RESOLUTION

NO. 110-95

FACT SHEET

DRIVEWAY VARIANCE REQUEST

PROPOSED DRIVEWAY VARIANCE
AT 3613 MAISON ROAD FOR A. MARBOIS
(GEORGIA DOT. STANDARD 6050)

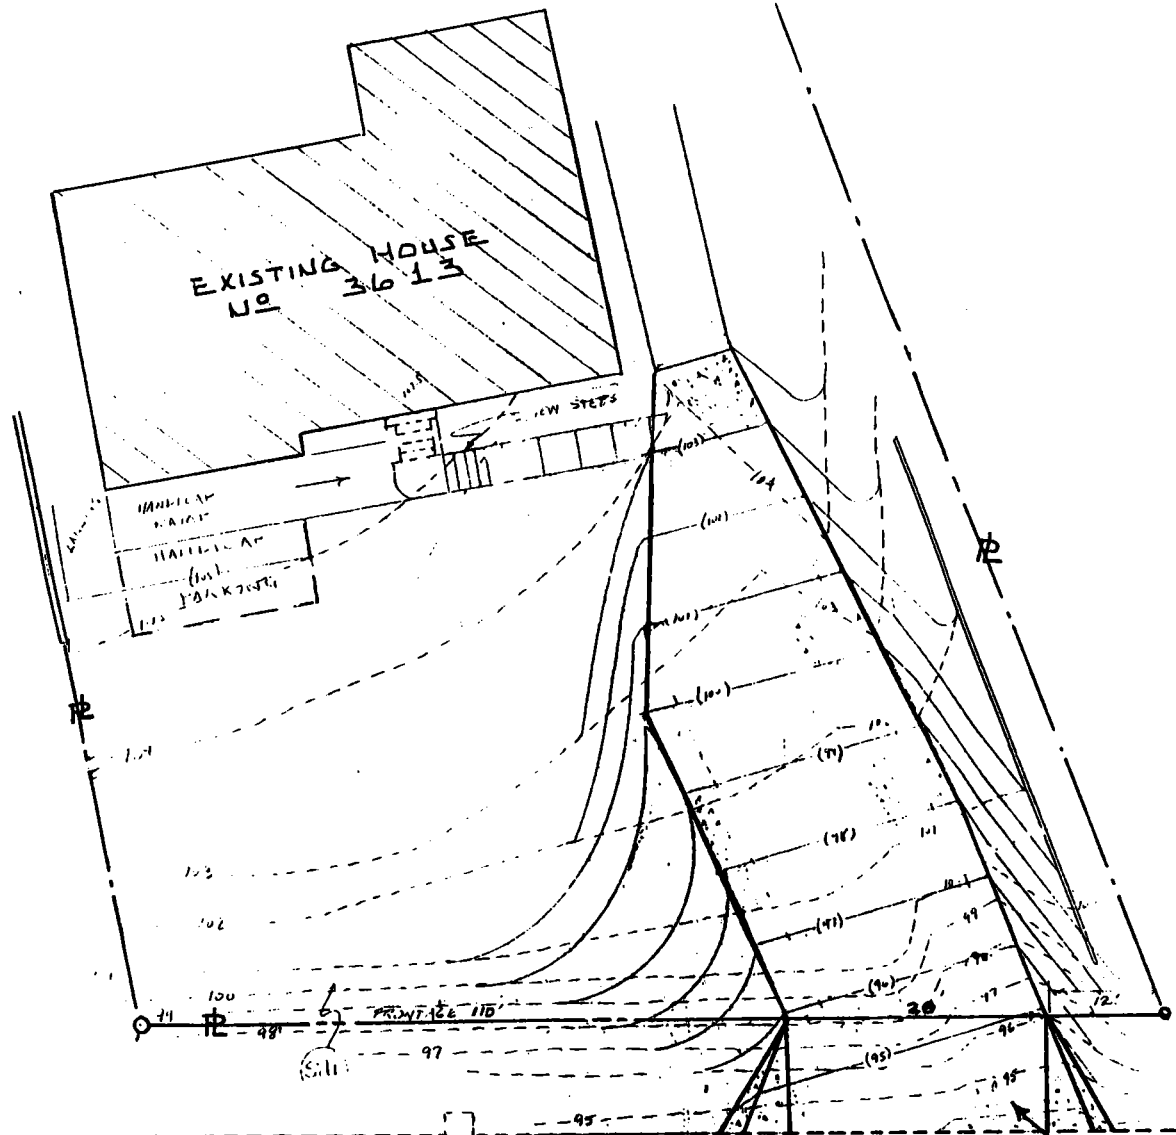
I ask that the offered blue print plans be modified to indicate the driveway width to be twenty (20) feet not twenty eight (28) feet. This is contingent on Georgia DOT approval which will be included in a forthcoming letter of consent to blue print design specs. Concurrence between Mr. Eddie Miles, city traffic engineer, and Mr. Gary Mailhot, of the Georgia DOT has been acknowledged.

I additionally request that I be granted a council hearing , for permit approval, due to design differences from code requirements (ie. curb cut and driveway pan) as soon as possible.

THAT A VARIANCE IS AUTHORIZED TO THE CITY CODE SECTION 22-32 OFF STREET PARKING REQUIREMENTS, (A) GENERAL REQUIREMENTS, PARAGRAPH 6 (a) DRIVEWAY ENTRANCES AND EXITS, FROM THE REQUIRED MINIMUM RADII OF 15 FEET TO ALLOW 7 FEET; AUTHORIZING THE TRAFFIC ENGINEER TO ISSUE A COMMERCIAL DRIVEWAY PERMIT TO ANTHONY MARBOIS LOCATED AT 3613 MACON ROAD TO CONSTRUCT A 20 FOOT WIDE DOT STANDARD 6050 CONCRETE DRIVEWAY ACCESSING MACON ROAD.
